ONSITE SEWAGE DISPOSAL SYSTEM

From: Oswald, Hank
Sent: Monday, June 08, 2015 10:01 AM
To: ;
Subject: 16105 Ed Warfield Road_BAT Plan Review

From: Oswald, Hank
Sent: Friday, June 12, 2015 8:15 AM
To: [REDACTED]
Subject: BAT Plan
Attachments: Setback Requirements.pdf

SITE PLAN FOR BAT INSTALLATION OF LOT-4
AGRICULTURAL LAND PRESERVATION SUBDIVISION PLAT OAKDALE - LOTS 1 - 4
AS RECORDED ON PLAT C.M.P. NO. 17633
16105 ED WARFIELD ROAD
4th ELECTION DISTRICT HOWARD COUNTY, MARYLAND
TAX MAP: 13, GRID: 23, PARCEL: 356
TAX ID# 04-369718

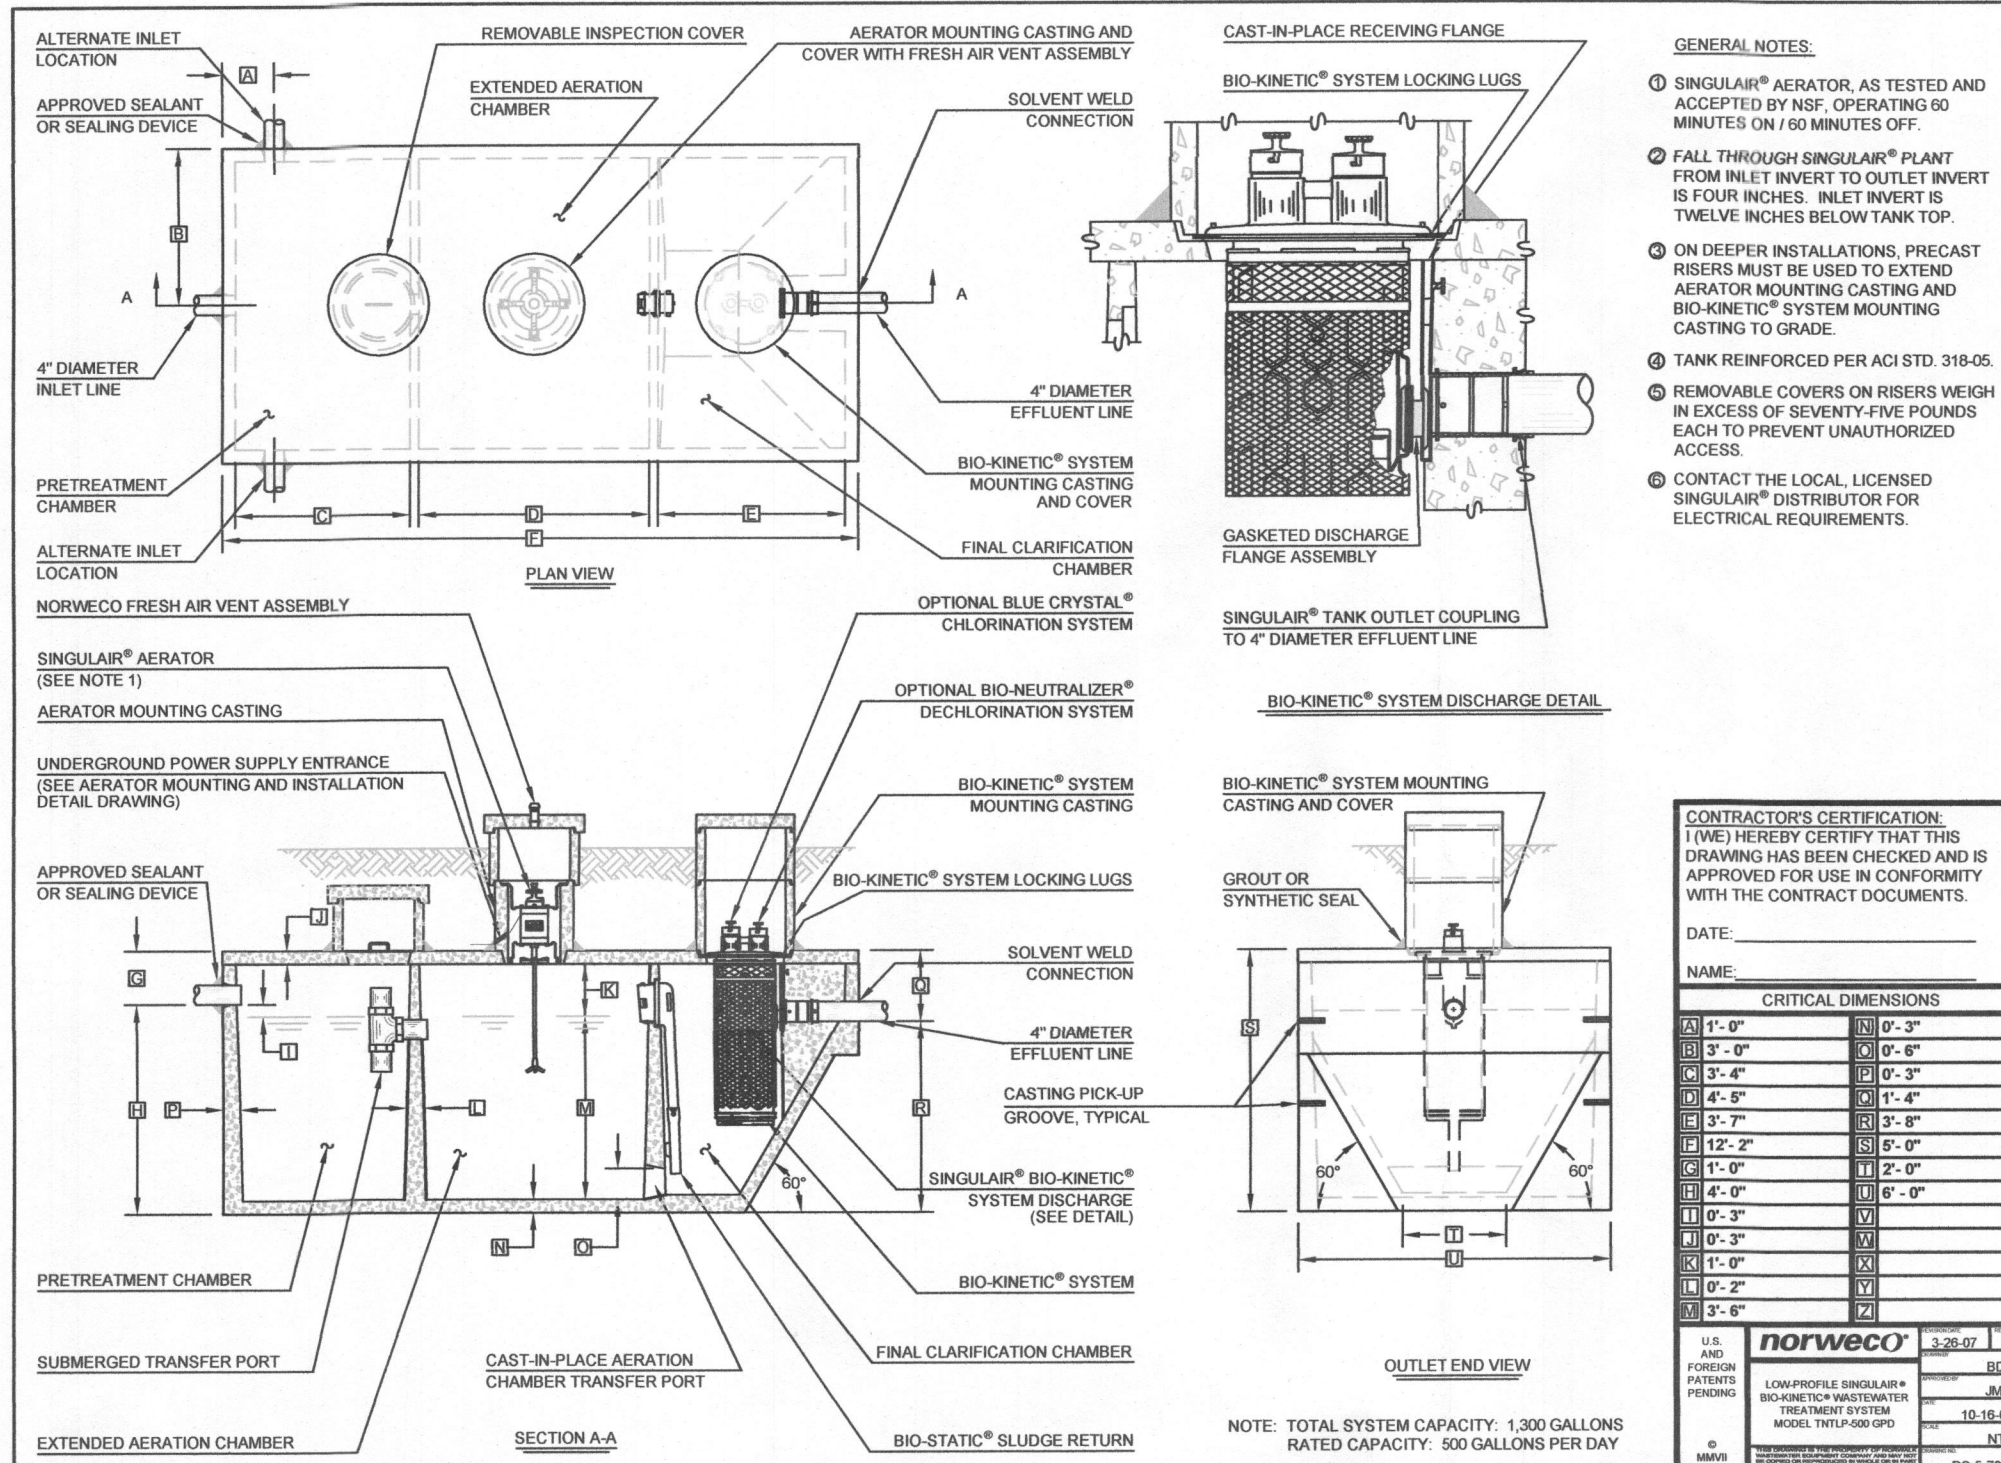
In looking at the floor plans, the wall adjacent the septic tank appears to be open space in the basement. The setback requirement for septic tank to house with basement is 20 feet. The BAT plan shows only 11 feet. Also, please show at least the initial and replacement system calculations on BAT plan.

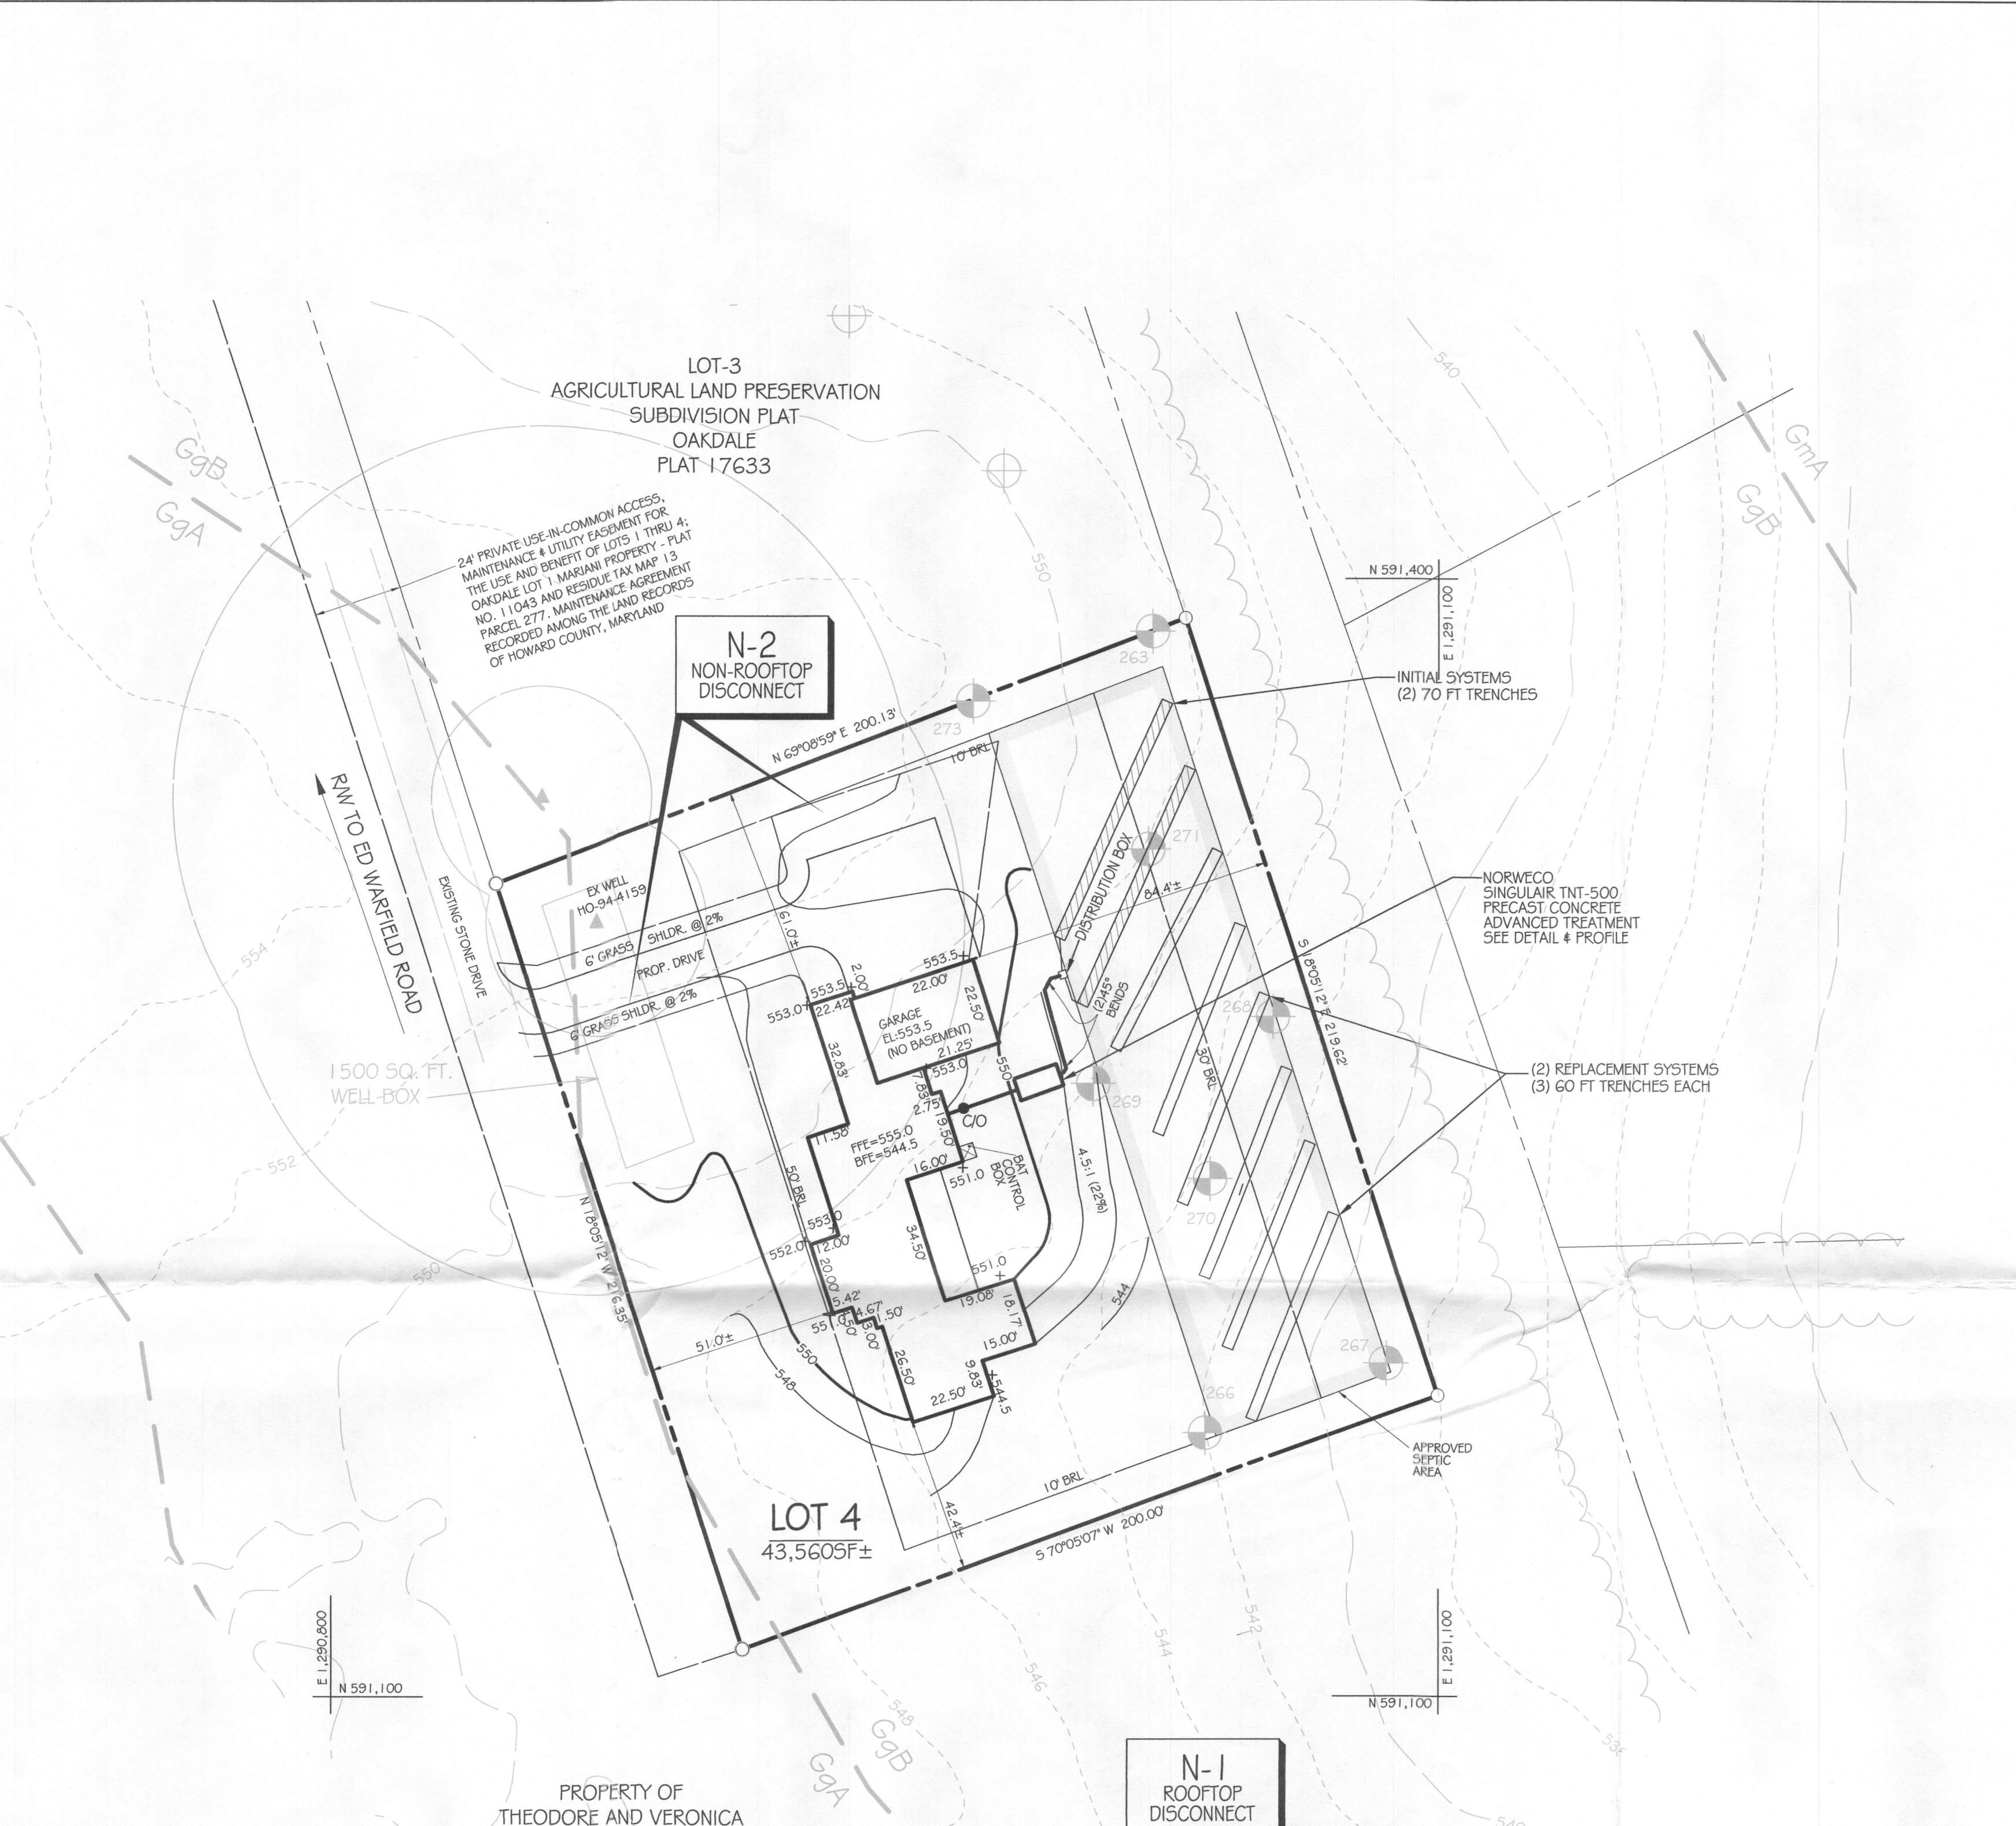
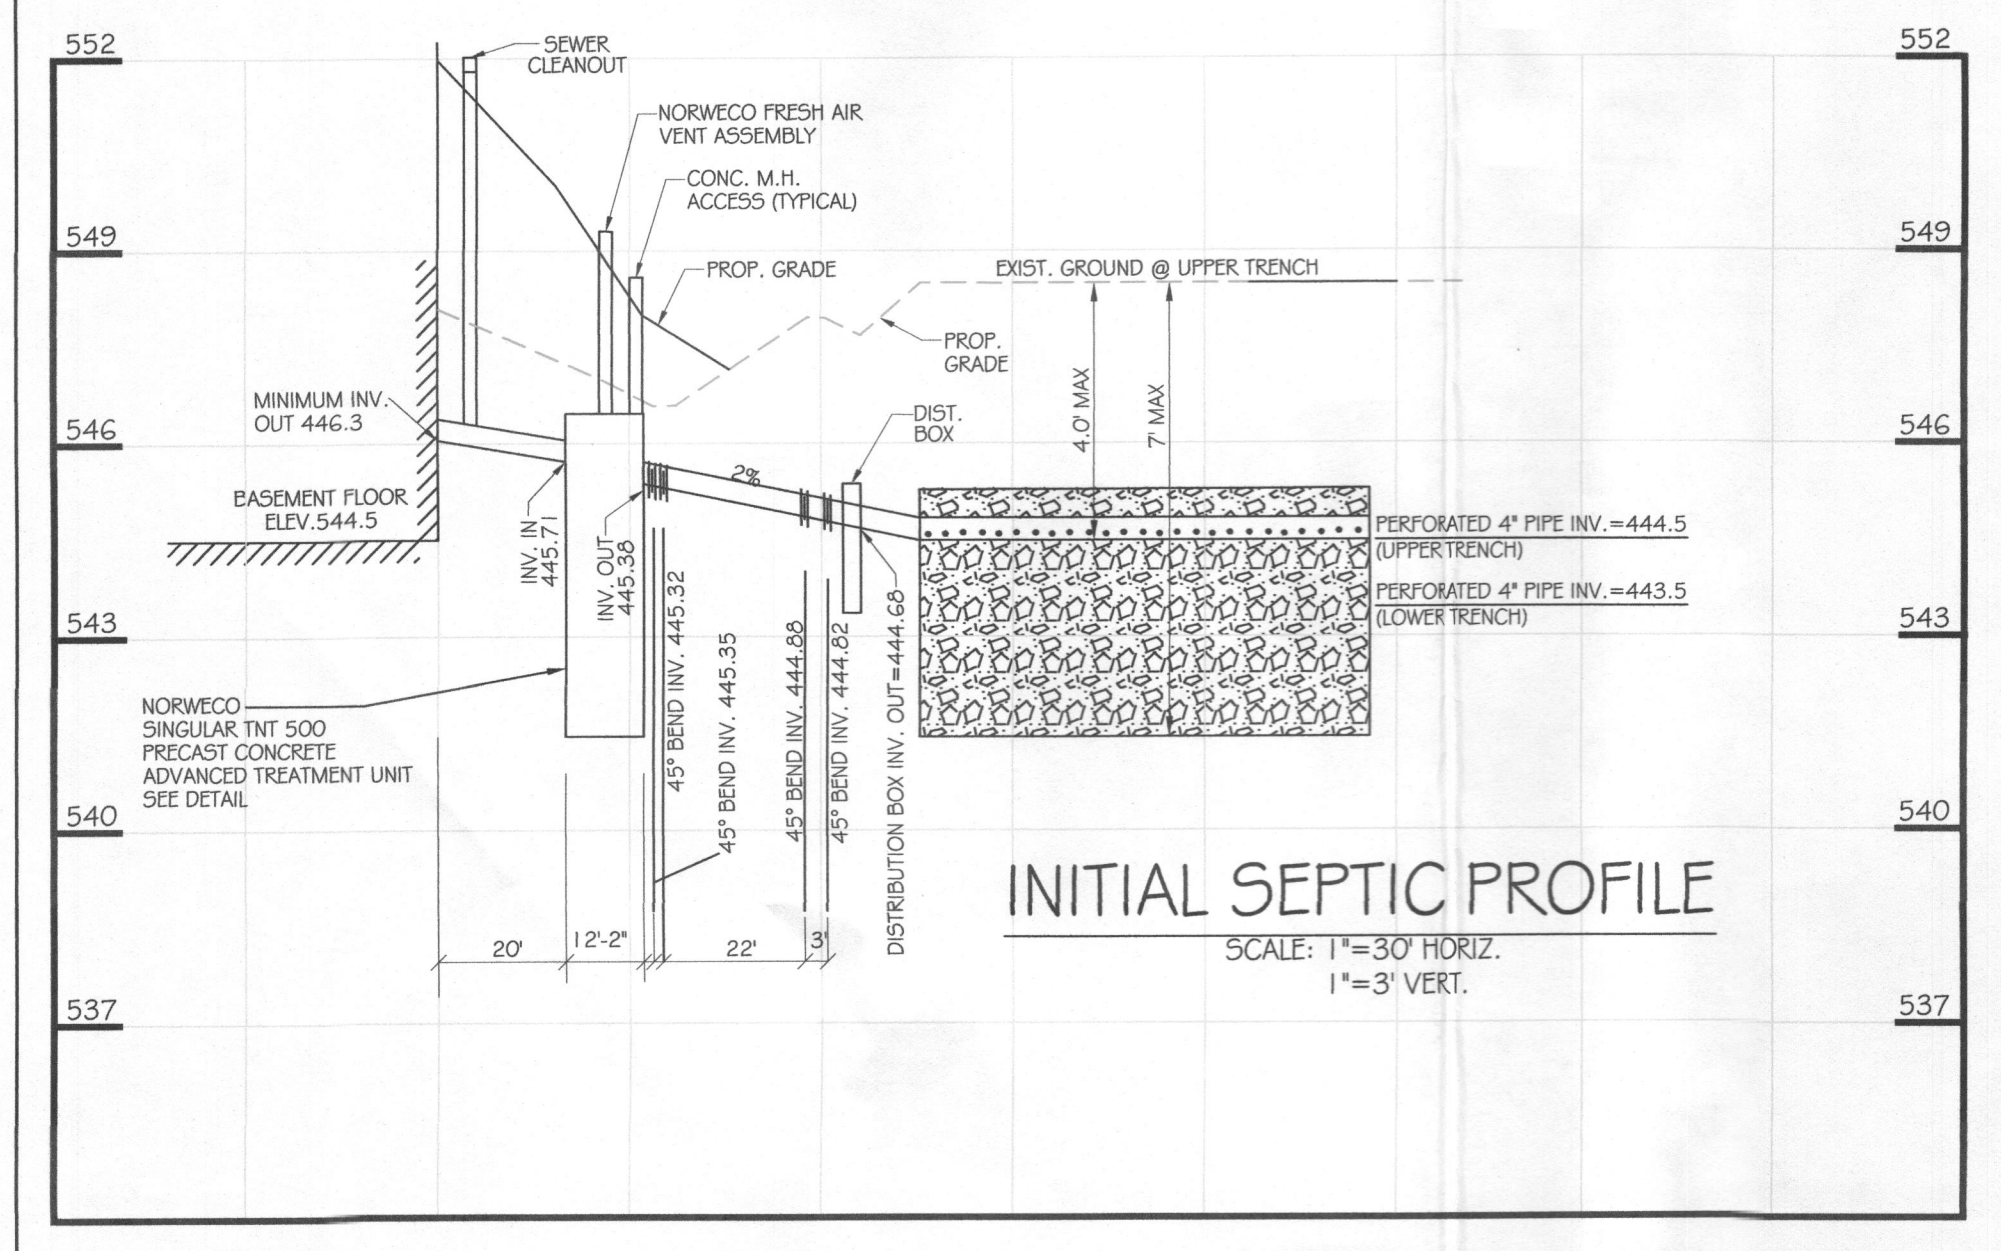
In review of the BAT plan, the septic specs for the initial and replacement systems indicate that the invert exceeds the 4 foot maximum depth requirement. The invert (i.e. the bottom of the pipe) cannot exceed 4 feet mainly because of OSHA requirements but it also provides greater capacity at shallower depths. Please revise the BAT plan accordingly and submit for review.

- SEWAGE DISPOSAL SYSTEM SPEC'S:**
- APPLICATION RATE= 0.8
 - DESIGN FLOW= 600 G.P.D. (4 bedrooms)
 - WIDTH OF TRENCH= 3 FEET
 - MAXIMUM PIPE DEPTH:
 - INITIAL SYSTEM = 4.0 FEET
 - REPLACEMENT SYSTEMS = 4.0 FEET
 - DEPTH OF STONE BELOW PIPE:
 - INITIAL SEPTIC SYSTEM= 3.0 FEET
 - 1st REPLACEMENT SYSTEM= 4 FEET
 - 2nd REPLACEMENT SYSTEM= 4 FEET
 - MINIMUM TRENCH SPACING= 10 FEET BETWEEN
 - TOTAL LINEAR LENGTH OF TRENCH PER SYSTEM:
 - INITIAL SEPTIC SYSTEM= 139 FEET
 - 1st REPLACEMENT SYSTEM= 179 FEET
 - 2nd REPLACEMENT SYSTEM= 179 FEET
 - INITIAL SEPTIC SYSTEM= (2) 70 FT TRENCHES
 - REPLACEMENT SEPTIC SYSTEMS= (3) 60 FT TRENCHES

REVISIONS	
DATE	REASON
6-9-2015	MAX PIPE DEPTH
6-25-2015	BAT TANK LOCATION
